Regulations Nos. 37 (Filament lamps) and 128 (Light emitting diodes light sources)

Proposal for Supplement 10 to the original series of Regulation No. 99 (Gas-discharge light sources)

Submitted by the expert from the International Automotive Lighting and Light Signalling Expert Group (GTB)*

The text reproduced below was prepared by the expert from GTB to introduce a new category, D8R. The modifications to the existing text of the Regulation are marked in bold for new or strikethrough for deleted characters.

Figure 1
Category D8R - Cap PK32d-8

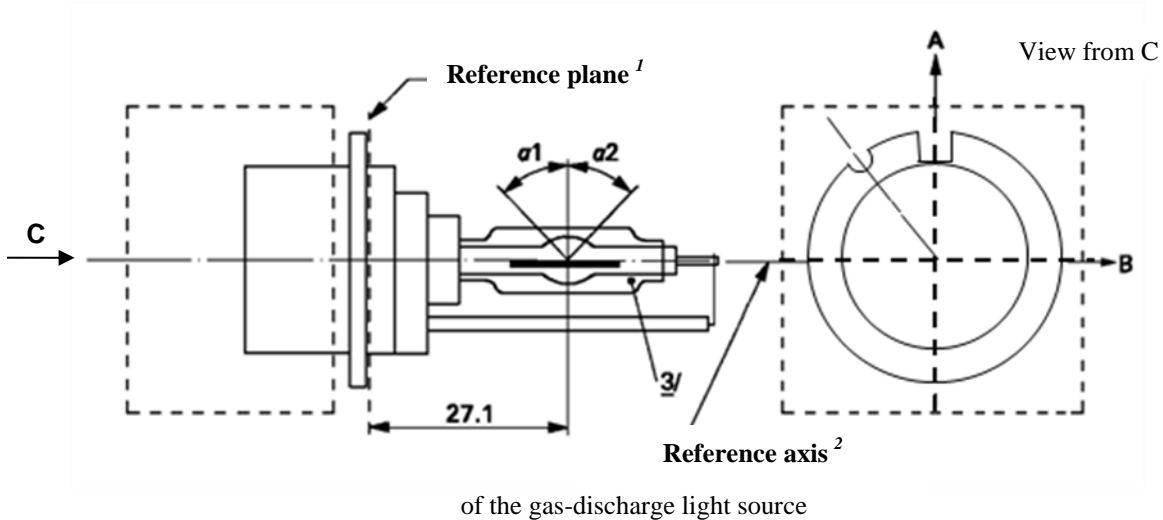
Insert new sheets D8R/1 to 6, after D8S/5, to read (see following pages; one page per sheet):

¹ The reference plane is defined by the positions on the surface of the holder on which the three supporting bosses of the cap ring will rest.

³ When measured at a distance of 27.1 mm from the reference plane and with respect to the mid-point of the inner bulb, the outer bulb shall have an eccentricity of 1 mm max.

Figure 2
Definition of reference axis¹

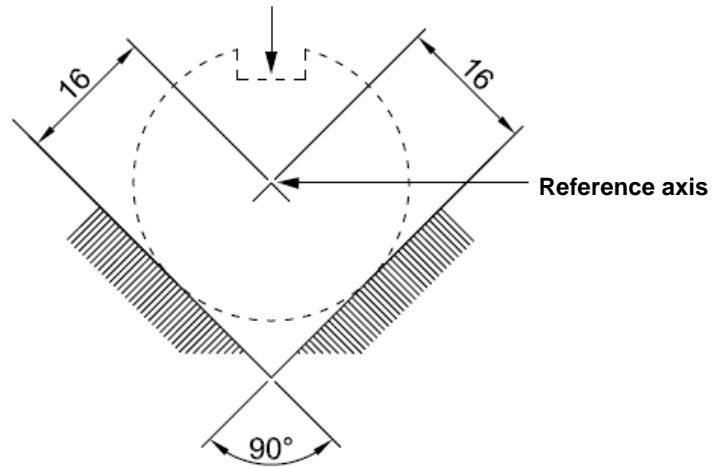
¹ The reference axis is perpendicular to the reference plane and crosses the intersection of the two parallel lines as indicated in figure 2.

Figure 3
Maximum lamp outline²

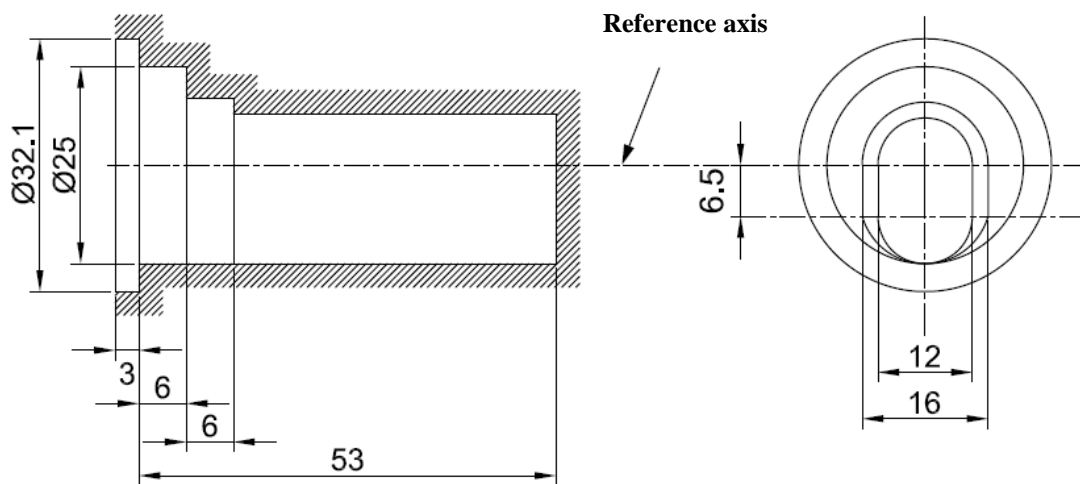
² Glass bulb and supports shall not exceed the envelope, as indicated in figure 3. The envelope is concentric with the reference axis.

Sheet D8R/3

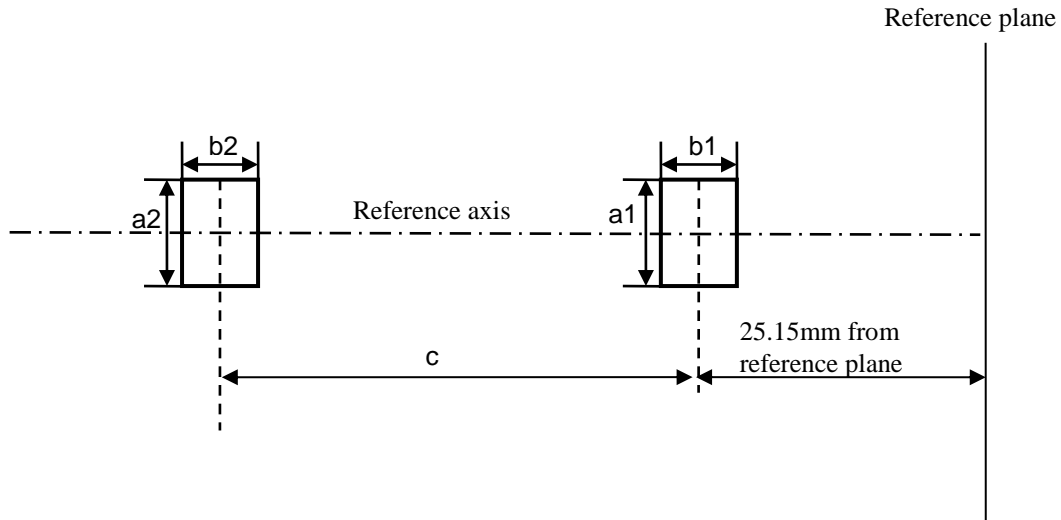
¹ The part of the bulb within the angles $\alpha 1$ and $\alpha 2$ shall be the light emitting part. This part shall be as homogeneous in form as possible and shall be optically distortion free. This applies to the whole bulb circumference within the angles $\alpha 1$ and $\alpha 2$ except for the black stripes.

Position of the electrodes

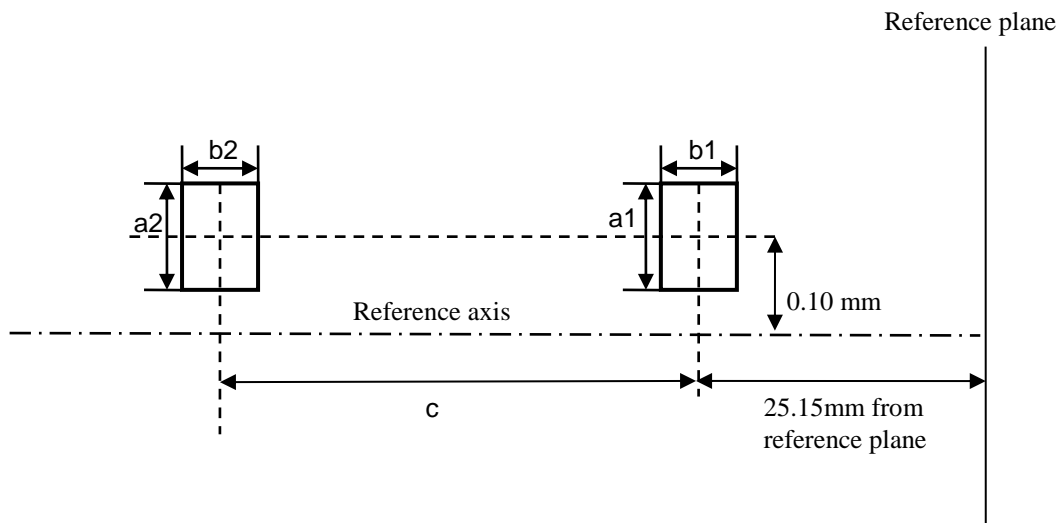
This test is used to determine whether the electrodes are correctly positioned relative to the reference axis and the reference plane.

The arc attachment point to the electrode nearest to the reference plane shall be positioned in the area defined by a1 and b1. The arc attachment point to the electrode furthest from the reference plane shall be positioned in the area defined by a2 and b2.

Position and form of the arc

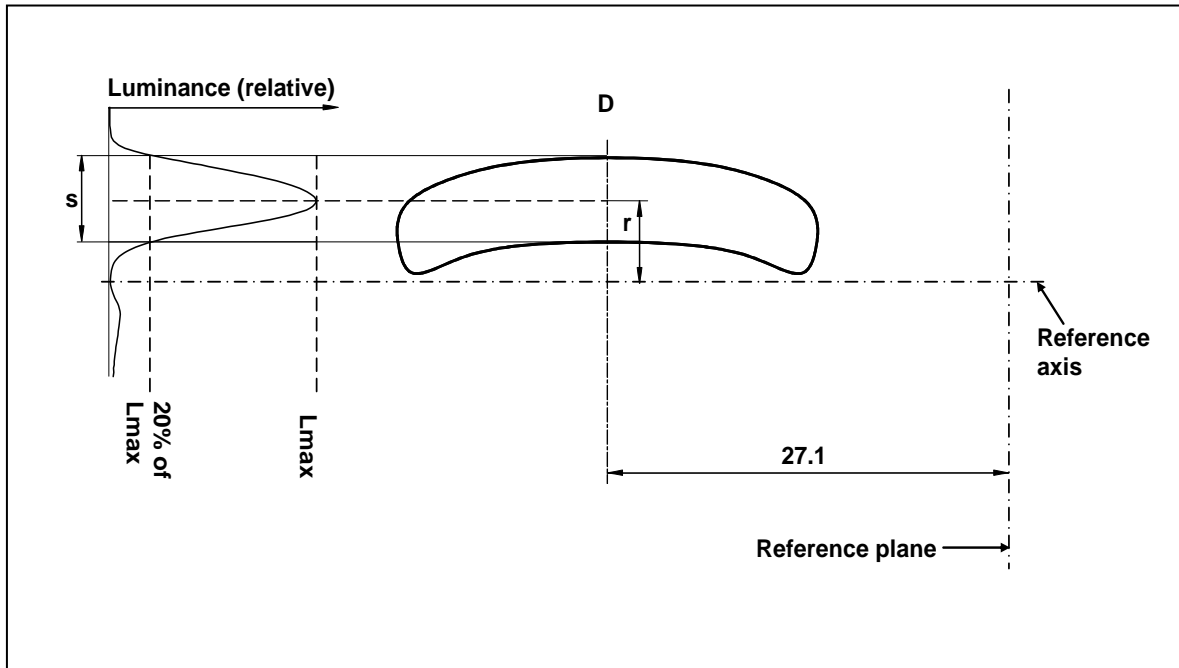
This test is used to determine the form of the arc and its position relative to the reference axis and the reference plane by measuring its bending and diffusion in the cross section at a distance 27.1 mm from the reference plane.

When measuring the relative luminance distribution in the central cross section as indicated in the drawing above, the maximum value shall be located within the distance r from the reference axis. The point of 20 per cent of the maximum value shall be within s .

Position of black stripes

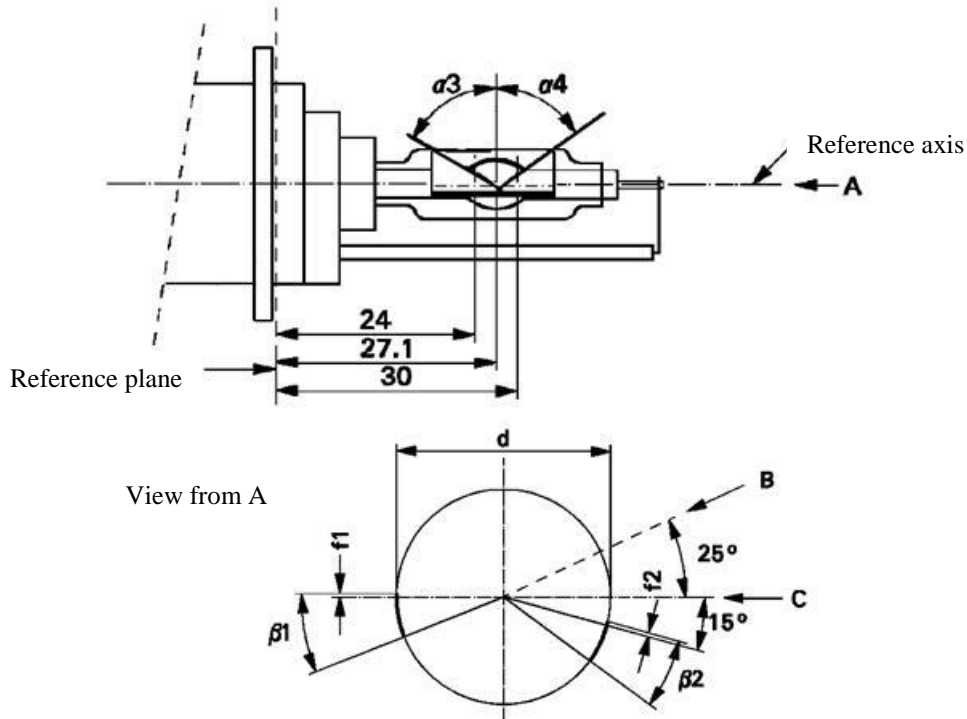
This test is used to determine whether the black stripes are correctly positioned relative to the reference axis and the reference plane.

When measuring the luminance distribution of the arc in the central cross section as defined on sheet D8R/5, after having turned the light source so that the black stripe is covering the arc, the measured luminance shall be $\leq 0.5\%$ of L_{max} .
